# FLOOR PLAN — REV N

## THE OFFICE IS EAST

REV N · 22 SEP 2026 8:45 AM · YOUR MARKUP READ OFF

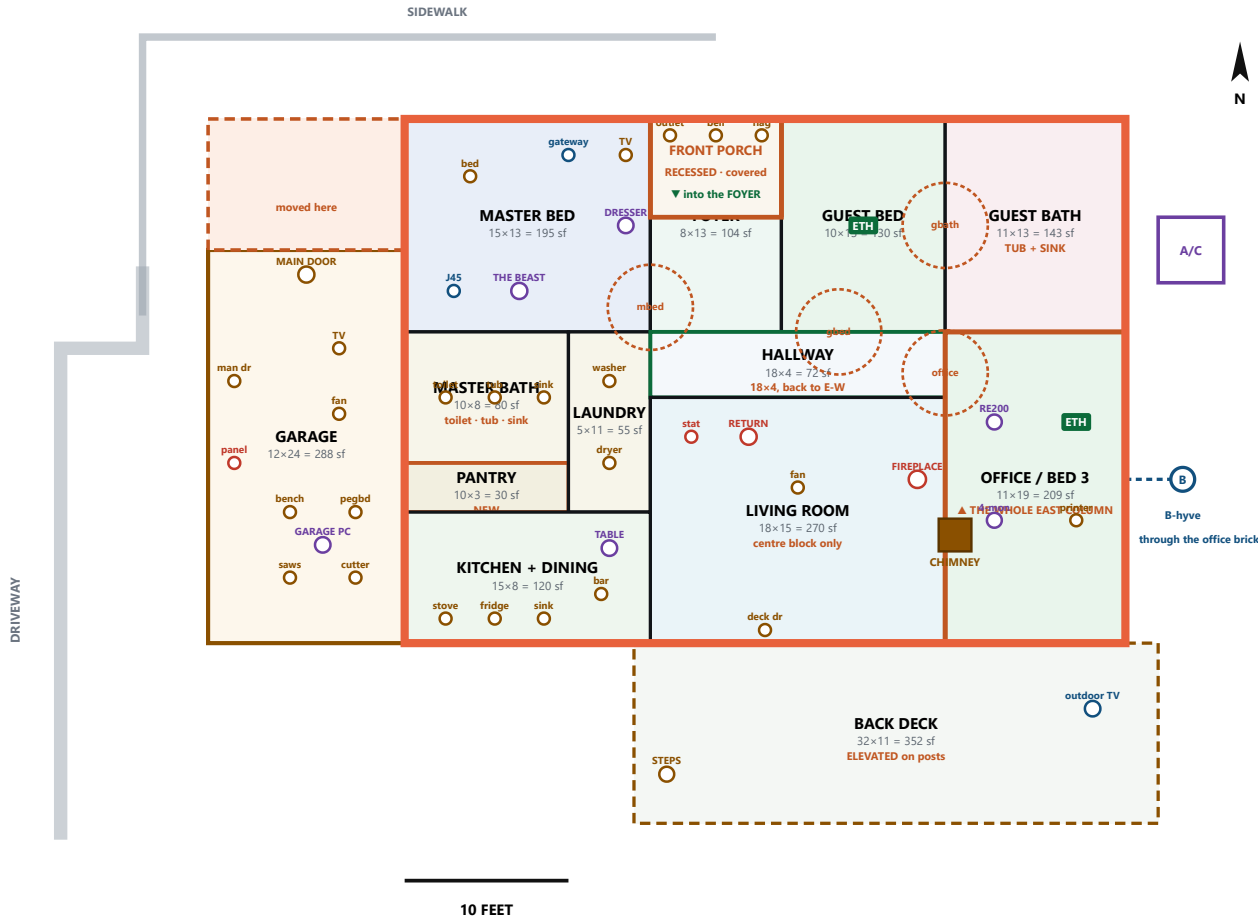
**You drew OFFICE across BOTH the 11x11 and the 11x8 below it**, with a line running out to the B-hyve. So the office is **the entire east column, 11 x 19 = 209 sf**, on the **EAST** wall — the brick the B-hyve is mounted through.

**That clears the contradiction I could not resolve.** When you said “the living room southwest corner is really the office”, the corner your pen actually circled is the **southEAST** piece. The office never moved west. Your pen says east, the B-hyve says east, and the chimney in the roof shot says the fireplace is east. **All three agree now.**

- **🔍 PANTRY** — a room that has never been on this plan. Drawn  $10 \times 3$  off the south end of the master bath, where your arrow pointed toward the kitchen. **The**

**size and the exact spot are my guess.**

- 🔥 **FIREPLACE moved to the LIVING ROOM'S EAST WALL**, where your arrow put it — and it lines up with the chimney on the east half of the roof.
- 🚽 **Master bath: toilet · tub · sink.**  
**Guest bath: tub + sink.** Neither room had a single fixture on it before today.
- 🛏 **DRESSER and TV on the master bedroom's east wall**, bed to the west, door at the southeast.
- 🍷 **Dining TABLE** at the east end of the kitchen, by the bar.
- 🪟 **Nine windows placed** — three north, four south (two kitchen, two living room), two east in the office.
- 🚪 **Four door swings** — master bed, office, guest bath, guest bed.
- 🚗 **DRIVEWAY down the west side and a SIDEWALK up to the porch.** First time either has been on the drawing at all.
- 🚶 **Deck:** steps at the **west** end, outdoor TV at the **east** end where you moved it, and the deck carried further east.

⚠ **One number I need you to settle, because it changes the square footage.**

A **recessed** porch is **carved out of** the heated floor area, not added to it.

Drawn at **8 × 6 that removes 48 sf**, so the house reads **1,360 sf** instead of 1,408.

Your sheet had the porch at **12 × 8 = 96 sf**. Recessed at that size the house drops to **1,312** and the foyer behind it gets very shallow. **So either the porch is smaller than 12 × 8, or the house**

**is deeper than 32 ft.** I drew the smaller one. Which is right?

So the **living room is the centre block only,  $18 \times 15 = 270$  sf**, and the doors work: from the hallway, **guest bed on the north side, office straight off the east end**. The hallway stays  **$18 \times 4$  east-west** — I turned it  $90^\circ$  in Rev M and **that was wrong. It is turned back**.
